STAFF RECOMMENDATION
1815 Lillian Street
January 15, 2020

Application: New Construction—Outbuilding (Detached Accessory Dwelling Unit)
District: Lockeland Springs-East End Neighborhood Conservation Zoning Overlay
Council District: 06
Base Zoning: R6
Map and Parcel Number: 08314021400
Applicant: Craig Kennedy, Bootstrap Architecture + Construction LLC
Project Lead: Melissa Sajid, melissa.sajid@nashville.gov

<p>Description of Project: Application is to construct an outbuilding that is less than twenty feet (20') from the rear of the house.</p> <p>Recommendation Summary: Staff recommends approval of the project with the following conditions:</p> <ol style="list-style-type: none">1. Staff approve the final details, dimensions, and materials of windows and doors prior to purchase and installation; and,2. Staff approve the color and details of the metal roofing and siding. <p>With these conditions, staff finds that the proposed DADU meets Section II.B.8 of the design guidelines and 17.16.030.G., the DADU ordinance.</p>	<p>Attachments A: Photographs B: Site Plan C: Elevations</p>
------------------------------------------------------------------------------------------------------------

SDO.2

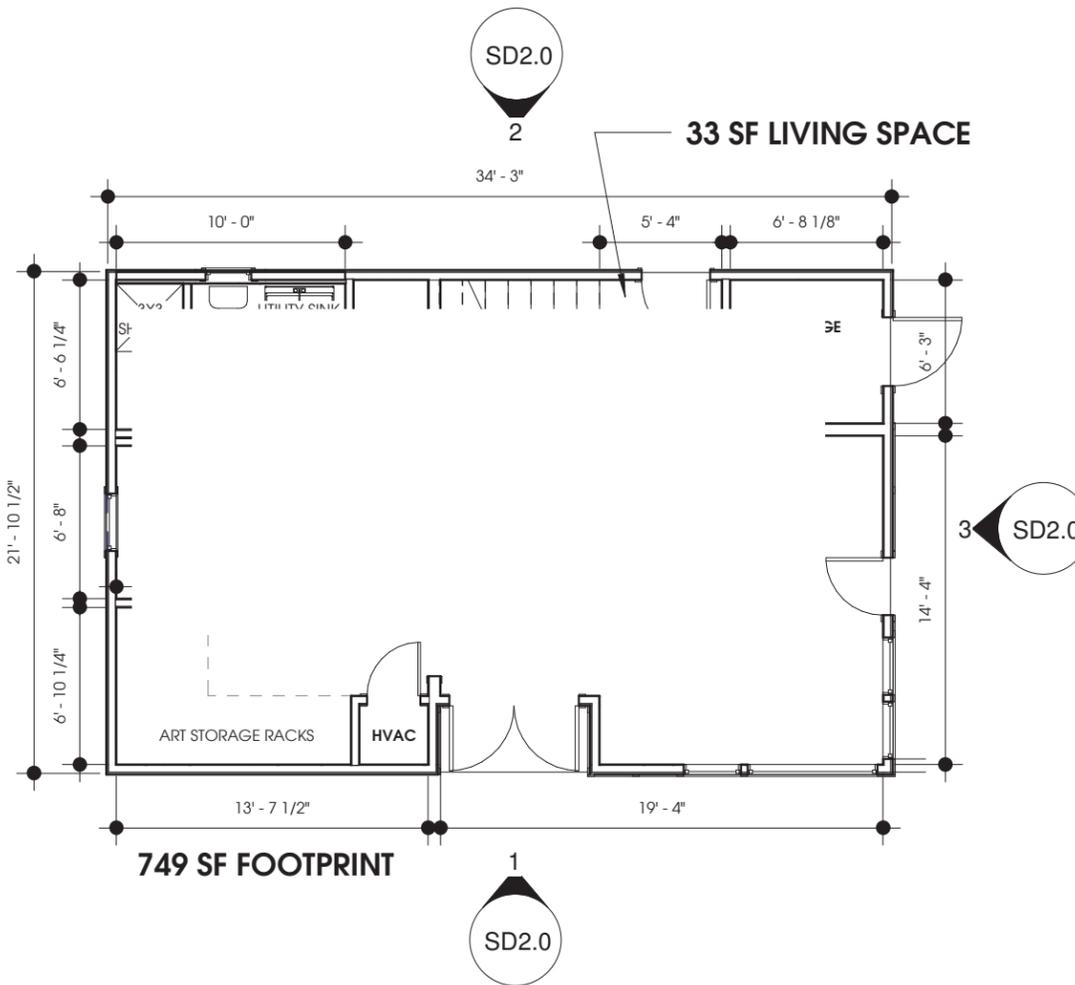
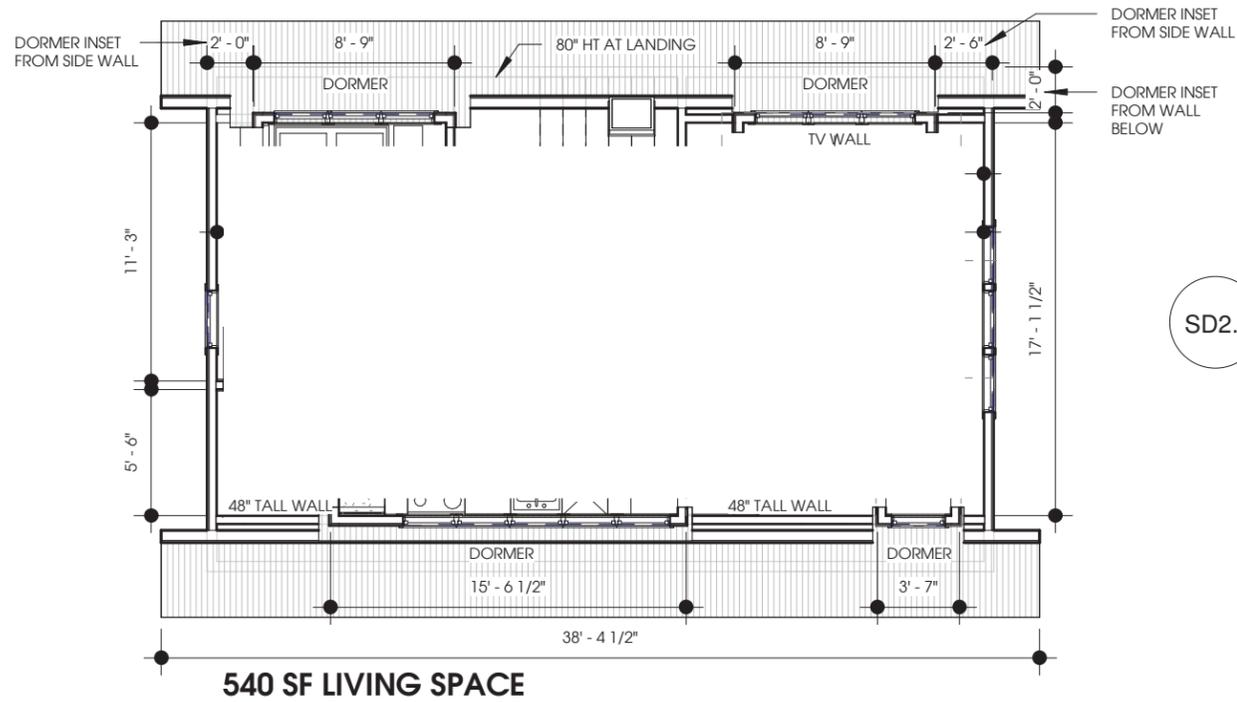
The accessory structure has a traditional form that incorporates modern detailing. The roof form and pitch of the dormers as well as the materials and fenestration pattern are modern elements that, while atypical of the historic context, are appropriate for an outbuilding. Staff finds the proposed design meets Section II.B.8 of the design guidelines and Section 17.16.030.G.8 of the Ordinance.

The plan mingles modern materials such as steel roofing, siding, and trim with more traditional materials such as board-and-batten siding and fiber cement trim. While the steel roofing, siding, and trim are not typical of the historic context, staff finds that these materials can be appropriate for an outbuilding that incorporates modern elements.

1. Staff approve the final details, dimensions, and materials of windows and doors prior to purchase and installation; and,
2. Staff approve the color and details of the metal roofing and siding.
